PUBLIC MEETING TO DISCUSS INDUSTRY RESPONSES TO INTERIM
STAFF EVALUATIONS FOR SPENT FUEL POOL INSTRUMENTATION
NOVEMBER 26, 2013

The information provided below is a sample of some of the licensee's responses with the necessary level of detail the NRC staff has found to be consistent with the NEI guidance, as endorsed by the ISG.

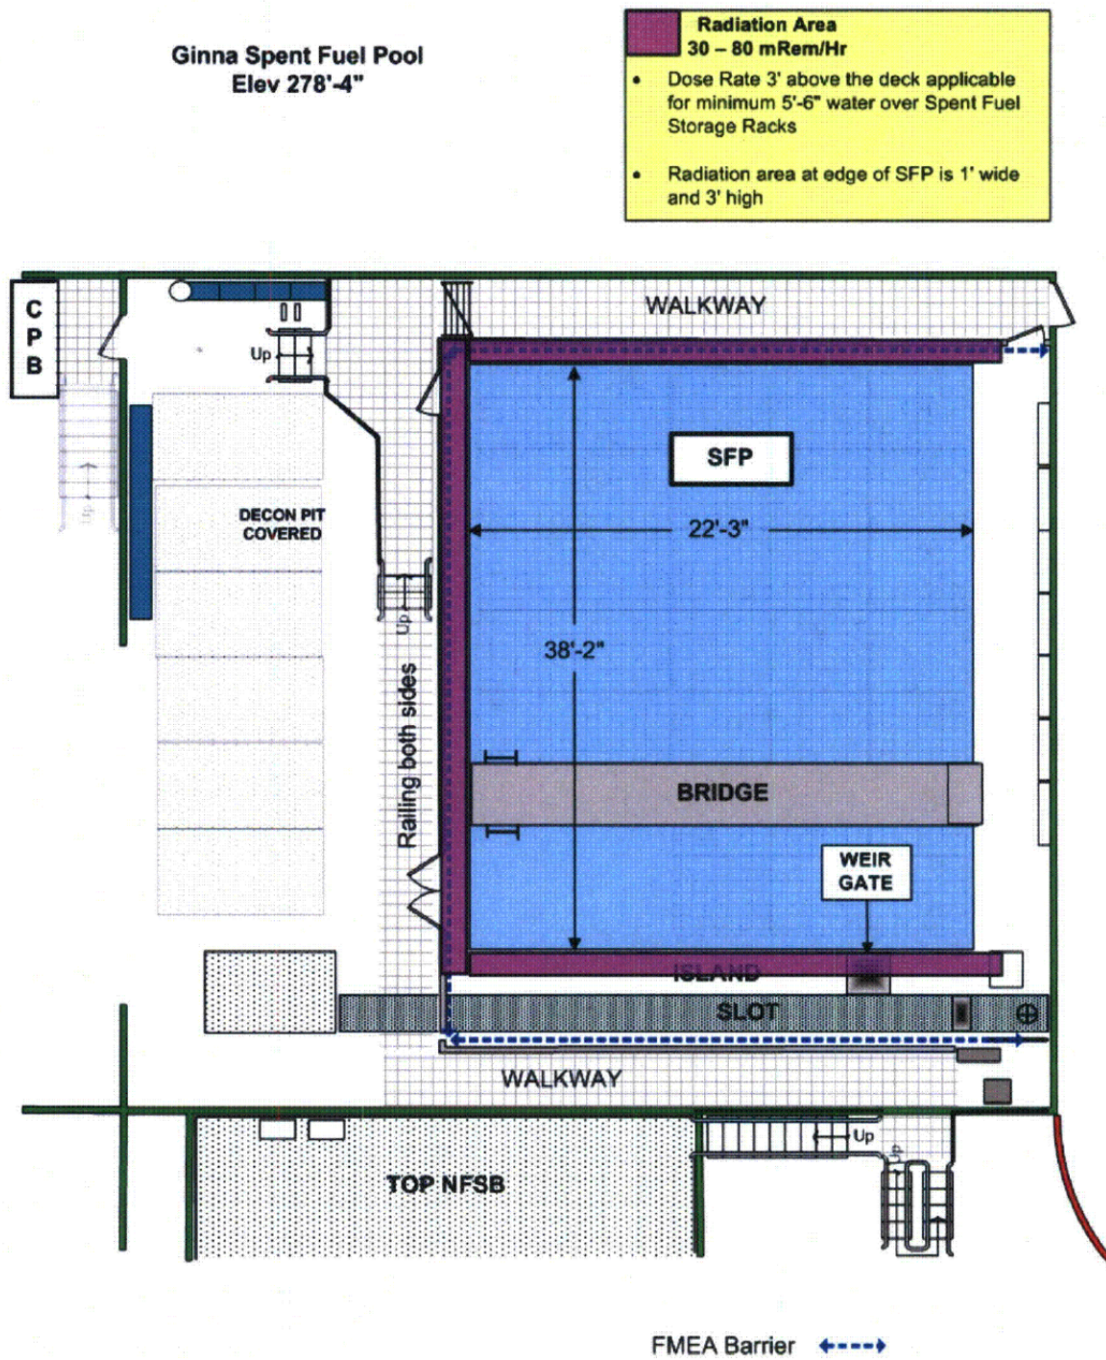
The calculation indicates that water coverage of 5'-6" above the racks is sufficient to ensure dose rates around the SFP deck area meet the acceptance criterion of ≤ 100 milli-rem per hour (mrem/hr). The Level 2 value has been established at - 5'-7" above the racks to provide additional margin.

Based on the calculation performed, with 5'-6" of water above the top of the SFP racks, Figure 2 depicts the projected dose rate locations on a plan view sketch, from the edge of the SFP up to 1' back from the SFP edge, and from 3' to 6' above the deck elevation. All areas surrounding the SFP under this condition are calculated to be less than 100 mrem/hr as indicated by Figure 2.

Figure 1

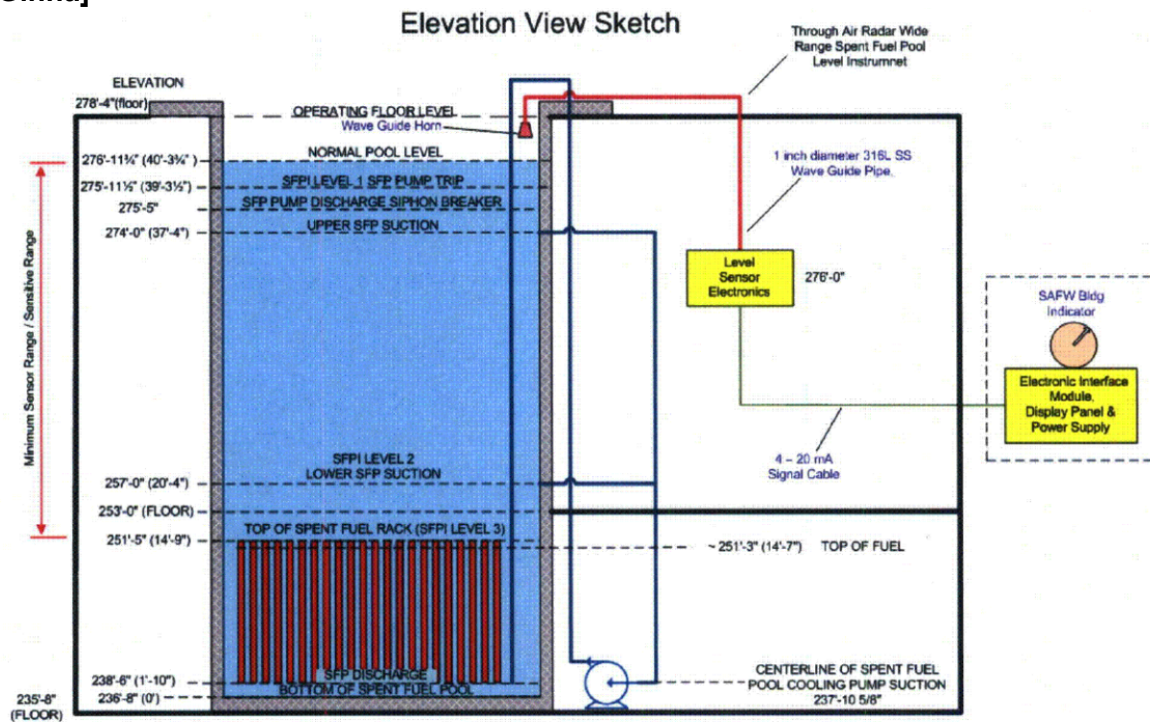
[Clearly labeled sketch with Levels 1, 2, and 3 and measurement range]

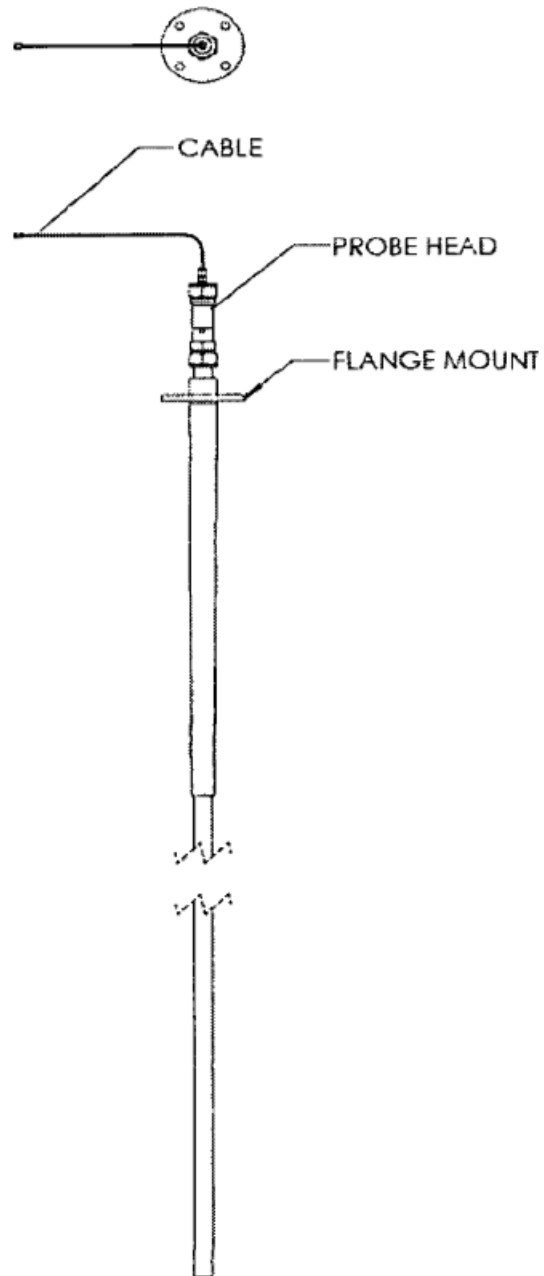
The loading on the probe mount and probe body includes both seismic and hydrodynamic loading using seismic response spectra that bound the IPEC design basis maximum seismic loads applicable to the installation location(s). The static weight load is also accounted for in the modeling described below but is insignificant in comparison to seismic and hydrodynamic loads. Analytic modeling is being performed by the instrument vendor using Institute of Electrical and Electronic Engineers IEEE 344-2004 methodology.

The simple unibody structure of the probe assembly makes it a candidate for analytic modeling and the dimensions of the probe and complex hydrodynamic loading terms in any case preclude meaningful physical testing.
